Amendments to the Drawings

The attached drawing sheet includes changes to Figure 1. This sheet, which includes Figure 1, replaces the original sheet including Figure 1.

FIG. 1

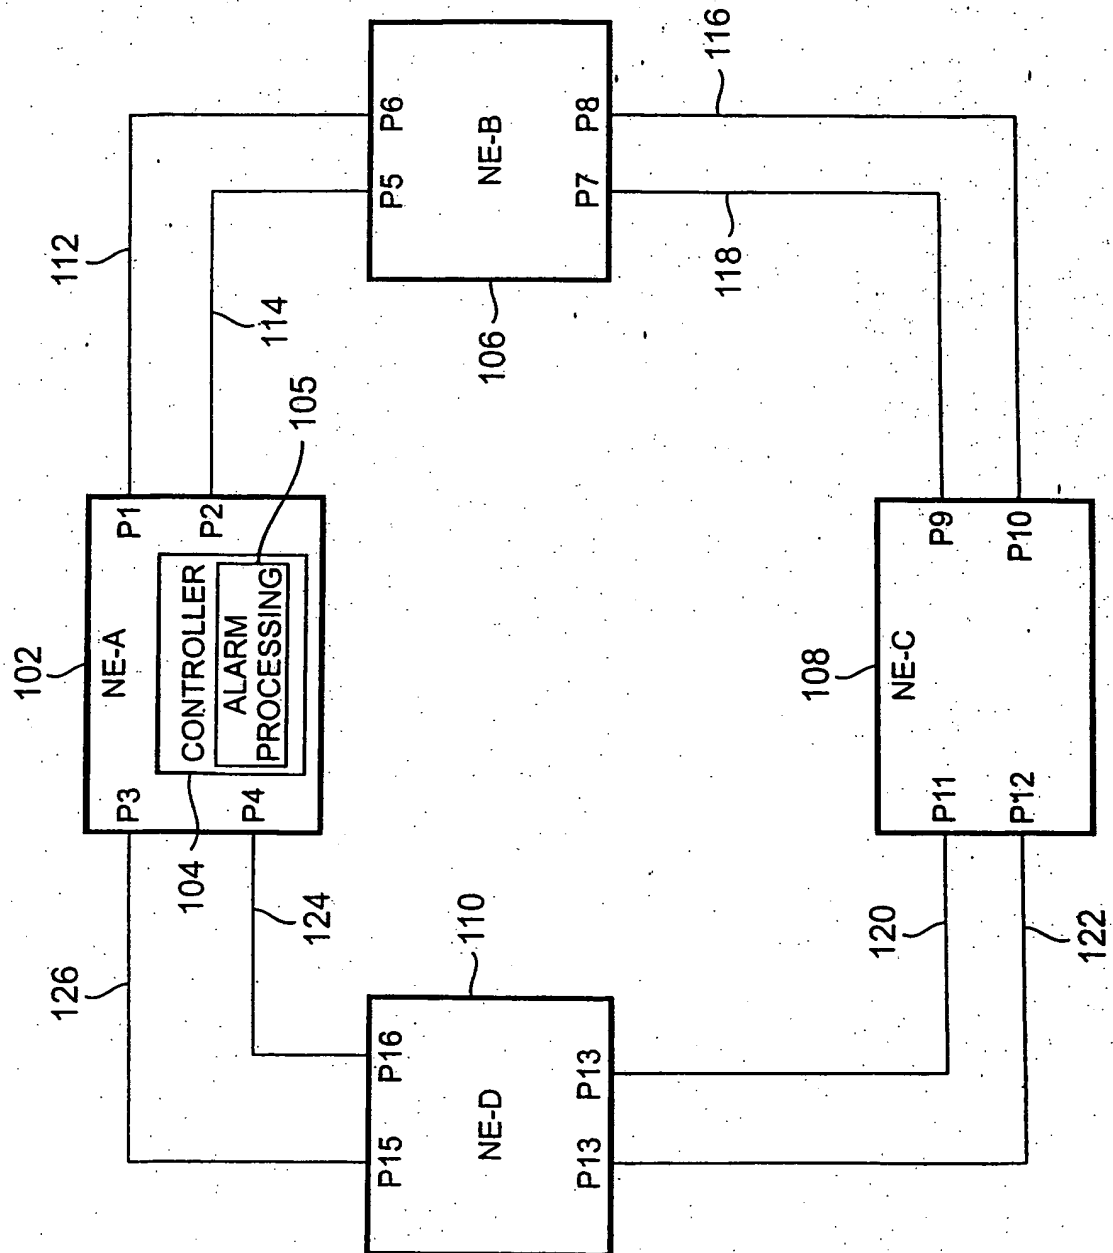
In Figure 1, a block depicting the alarm processing of the present invention, a descriptive label for the added block, and a reference number for the alarm processing block have been added.
